Determination 2017/017

Regarding the compliance of a concrete ramp to a door threshold and the refusal to issue a code compliance certificate for a house at 16 Pathways Drive, Kerikeri

Figure 2: The approved patio / cladding junction (detail 2 on page 7)

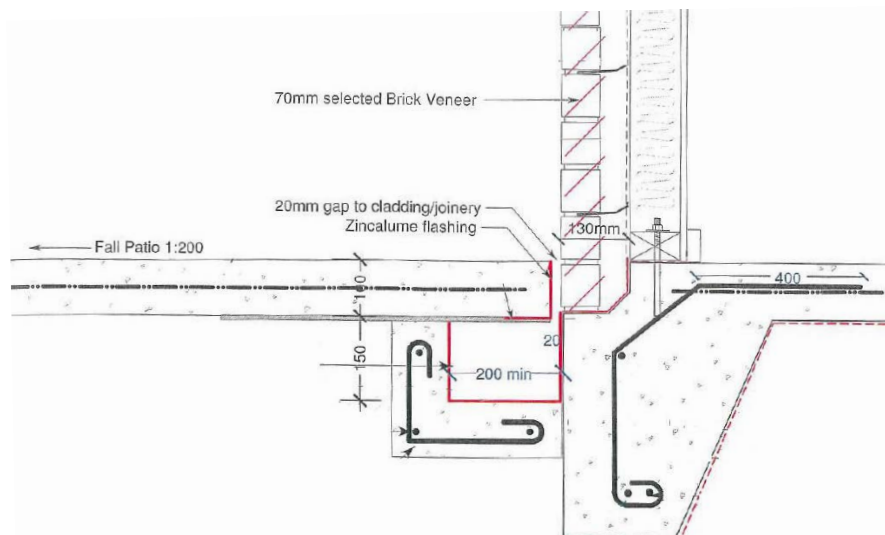
- 2.6 In an email to the applicant dated 11 January 2017 the authority stated it was of the view that the ramp did not comply with Clauses B2 and E2, and requested that the applicant remove the concrete slab and ‘build the drain as per consented drawings page 7 detail 2’. The authority stated the drain must be ‘open to level ground at each end and have clean out points on corners.’

- The details (Figure 2 and 3) shown on the foundation plan only refer to the 'concrete patio'. No paving is shown to the front entry, nor are any drainage channels as for the patio. There is no indication that the consented details are also applicable to the front entry.
- The authority has cited the high rainfall as evidence that the front entry does not satisfy the Building Code, and that the 'outfall' from the 20mm clearance

gaps either side of the entry ramp has not been considered. The amount of water that may be expected to drain from the largely sheltered ramp is not considered significant to warrant the need for a dedicated surface water outfall. I note the approved plans show both ends of the drainage channel to the larger and more exposed patio as 'Channel drain open at end', and is also noted on Figures 2 and 3 in the consented drawings: no outfall appears to be provided for to this drain.

Figure 3: The approved level entry off the patio (detail 2 on page 19)

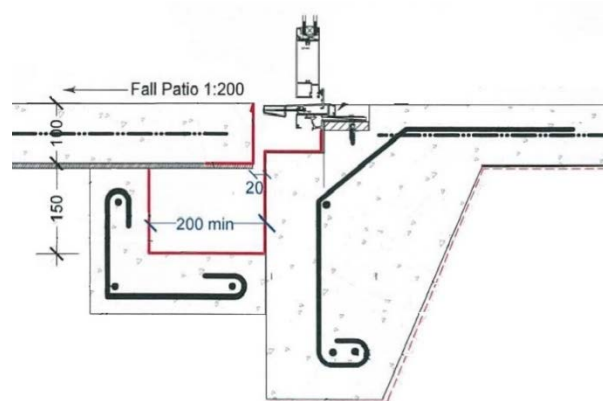
4.2.2 On the consented plans (Sheet 6), there is a notation that states 'Level threshold for all exterior doors...Refer detail 2 page 19 for level threshold door sill details'. The drawings identified that all doors were proposed as level threshold, with the consent documentation including a level entry doorsill detail (Figure 3). The detail referenced the adjacent patio slab with a fall of 1:200.

- 4.2.3 The applicant has stated in their submission that the doorsill detail (Figure 3) is only applicable to the 'uncovered patio concrete area at the rear of the house'. On the consented drawings, (Sheet 6) the level entry detail and associated drainage channels are specific to the patio area I to the north west of the building (see Figure 1).

- 4.2.4 I consider Figure 3 is not specific to the detail intended for the entry door and the associated drainage channels are only shown to the patio area. This discrepancy should have been addressed at consent stage.

4.3.4 The authority requested that the applicant construct the ramp in accordance with the level entry detail (Figure 3) in order to achieve compliance with the Building Code. However, I am of the view that the consented level entry detail provides a solution that is no better to that as-built: the consented detail has similar maintenance requirements to that as-built.

Figure 4: The junction of the as-built entry door and concrete ramp

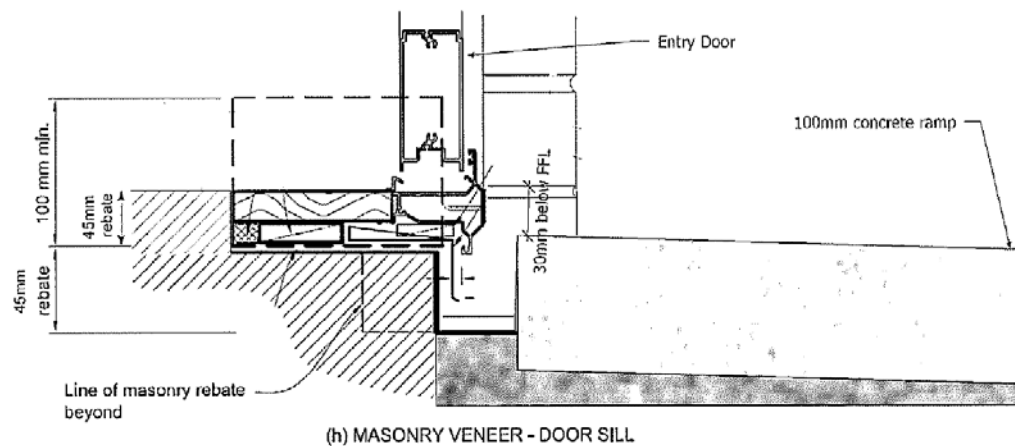
- 4.2.5 The as-built threshold detail to the front entry is shown in Figure 4. From the as-built detail and photographs provided by the applicant, it is evident that the concrete ramp is lower than the floor by 30mm at the door and approximately 60mm at the lowest point of the ramp adjacent to the wall. I note that the concrete ramp appears to be above the base of the cladding (above the rebate in the floor slab), however, it is not contact with the cladding due to the 20mm gap.

- The entry door threshold is in a very sheltered position. The threshold is recessed 1200mm into the front elevation with, in effect, a 1750mm deep soffit overhang. It is important to note that while Kerikeri does receive higher rainfall amounts compared to the surrounding areas, the inland and sheltered areas of Northland are ‘among the least windy in the country, with mean annual wind speed at...Kerikeri about 10 km/hr’⁶. Little, if any, wind-driven rain will reach the door threshold itself. However, I note that wind-driven rain will reach the side walls of the porch, and water must be able to safely be removed from the base of the cladding and ensure it does not enter through the weepholes.

- The ramp has a significant fall (1:40) away from the door threshold. The steep gradient will be effective in draining water away from the entry and preventing ponding.

- Any debris build-up in the 20mm clearance gap between the ramp and the building will be readily observable. The gap is able to be cleaned out by the owners, as part of the building’s regular maintenance.

- The top of the ramp at its highest point is still 30mm below the finished level (the exterior paving in Figure 17B of E2/AS1 is shown higher than the internal floor level).

- The 20mm clearance at the sides of the ramp between it and the masonry veneer cladding will allow any water to drain away from the building. (However, it is noted both gaps drain to a raised garden area finishing against the ramp.)
- The treatment of the timber framing has not been identified on the drawings provided, however, there is no dispute that the framing is not treated to an acceptable level.

4.3.3 I consider it unlikely that water will threaten this junction, and have a detrimental impact on the cladding system due to the mitigating factors noted. This part of the building envelope is well protected from the effects of external moisture, and any water that may penetrate the masonry veneer will be able to dissipate without causing undue dampness, and damage to the building elements. I therefore consider the entry door threshold and associated ramp satisfy Clause E2.3.3.

4.3.6 As noted in paragraph 4.3.2, the 20mm clearance gaps either side of the ramp run to garden area finished against the ramp. In my opinion there needs to be a clear space of some description provided to ensure the 'exit' points for these gaps remain visible, and unobstructed. I am of the view that once this has been addressed the wall cladding system will continue to meet the durability requirements of Clause B2.3.1.

- 4.5.1 The concrete ramp and ground level clearances have been constructed with mitigating factors to reduce the risk of water penetration into the cladding and the building envelope. I note that the applicant will be required to ensure the channels are open ended alongside the concrete ramp. Once this has been addressed, in my view the building work will satisfy Clauses B2.3.1 and E2.3.3.

- 4.5.3 I consider the alteration of the doorsill detail a minor variation and a record of the minor variation will be required for the issuing of the code compliance certificate.
